CHANGE ORDER

Project Name: **Haverhill Consentino Middle School** CO No. **001 (R2)**

Architect's Project No. **21-0818**

CCD / PR / PCO #	Description	Amount
001-R1	Abatement Lump Sum	\$ 0.00
002	FGR-1 at Receiving : Increased size of floor grille in the receiving area to meet LEED requirements	\$ 6,896.38
007	Decking Changes: composite decking in lieu of cellular decking	(\$1,541.00)
003-R1	Electrified Door Hardware: revisions to hardware sets	\$4,832.45
014-R1	Unsuitable Materials: removal of unsuitables from the site	\$ 12,787.74
Total		\$ 22,975.47

JD-05

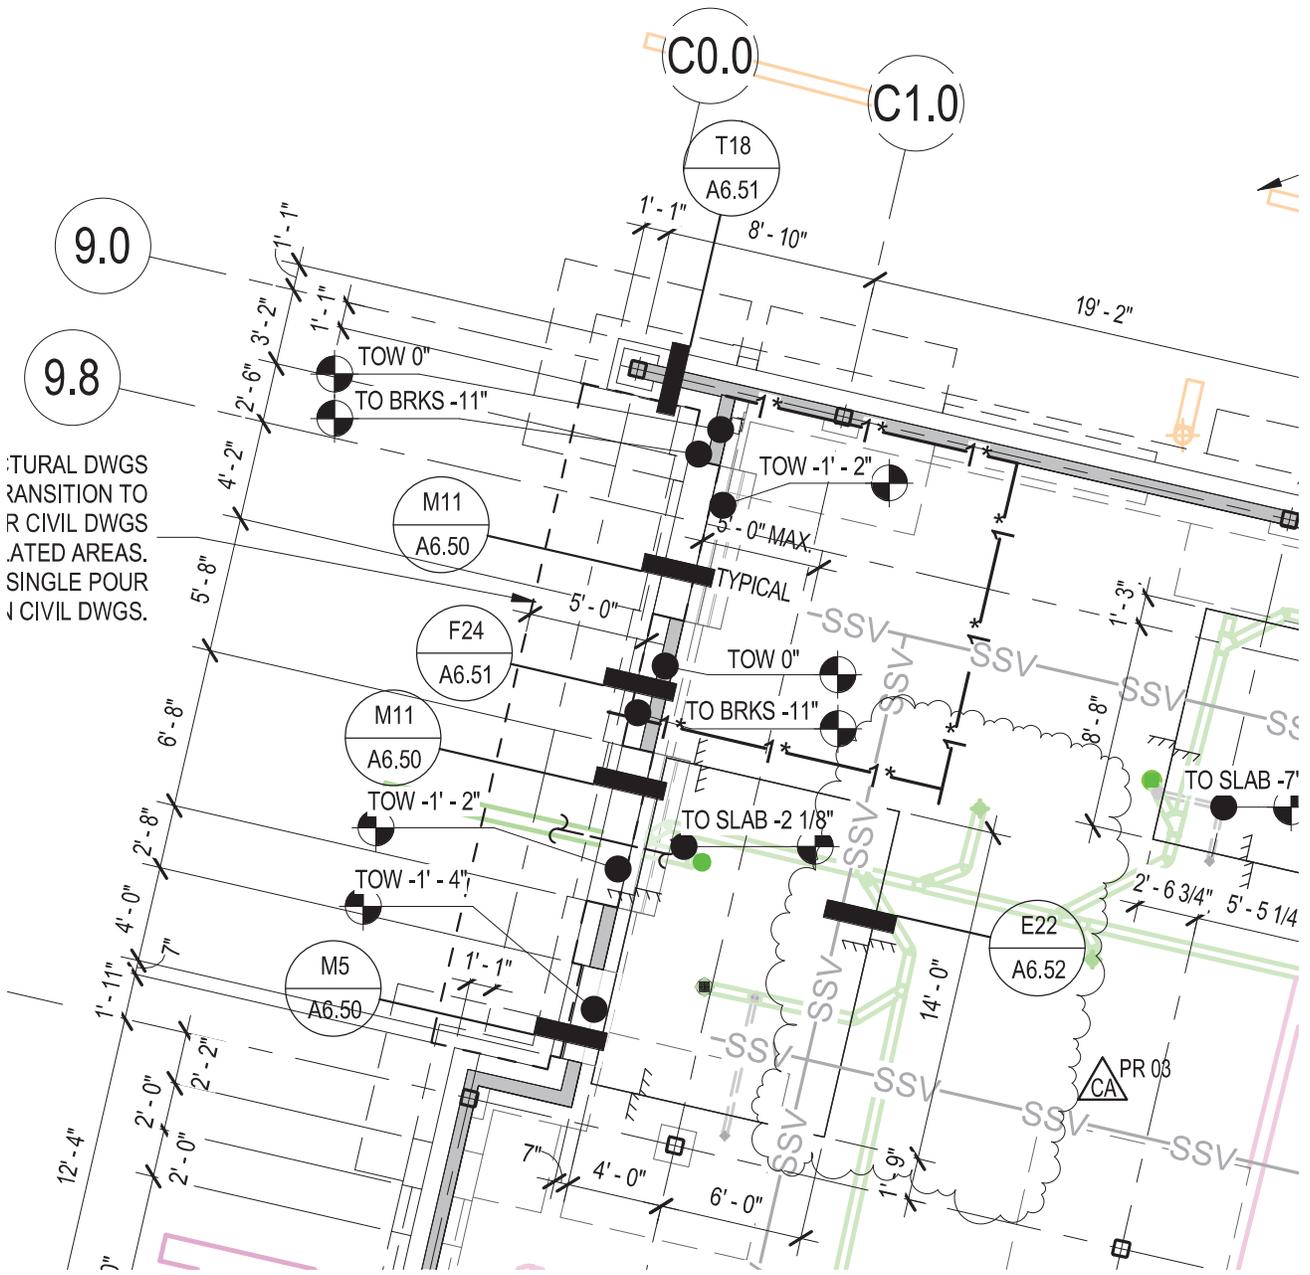
At Sheet A0.13, Level 1 HCP - Area C, revise Floor Grille as shown on the attached sketch **JD-05**. Make similar revision to **S1.13**.

JD-06

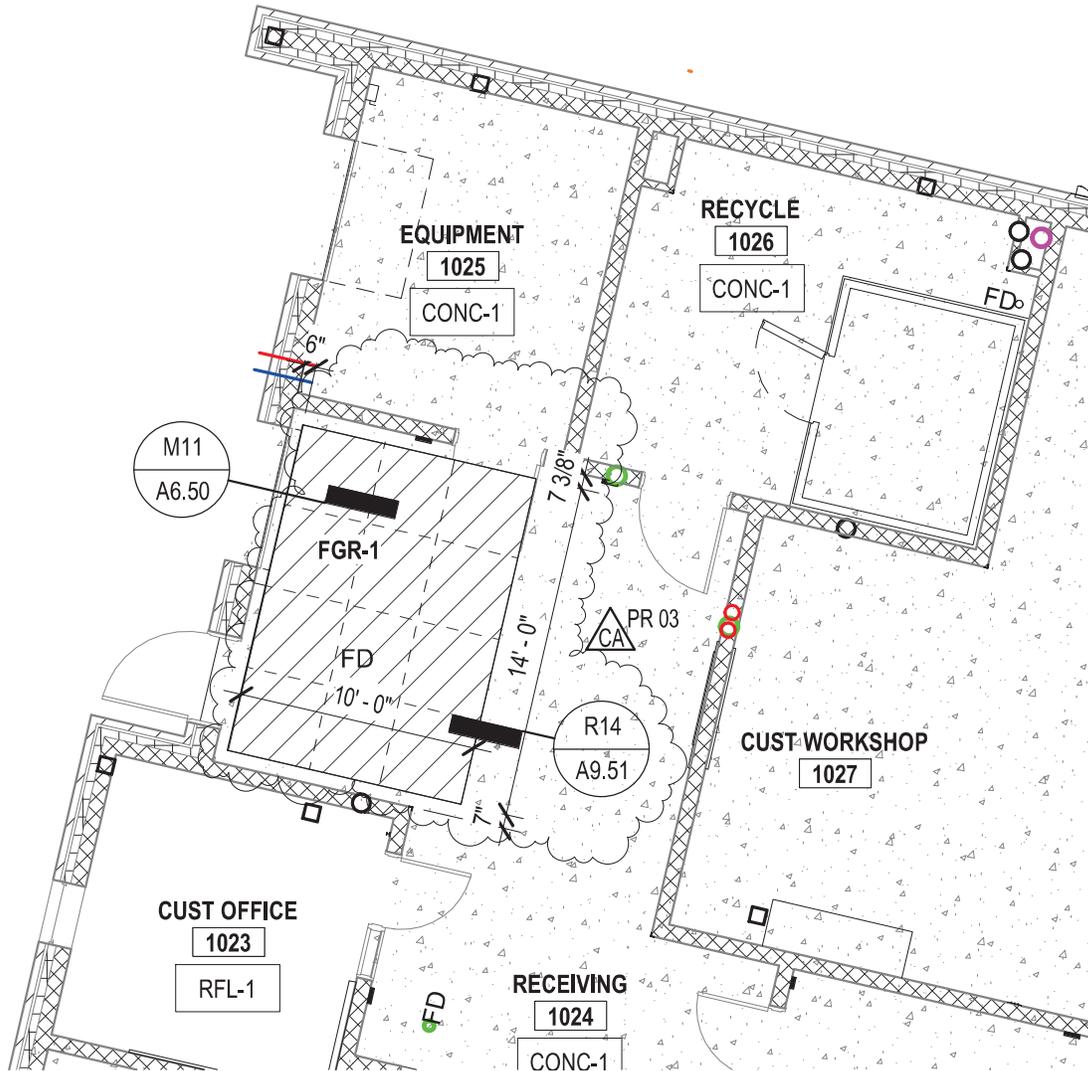
At Sheet A9.13, Level 1 Finish Plan – Area C, revise Floor Grille as shown on the attached **JD-06**
Make similar revisions to A1.13 and AQ1.13.
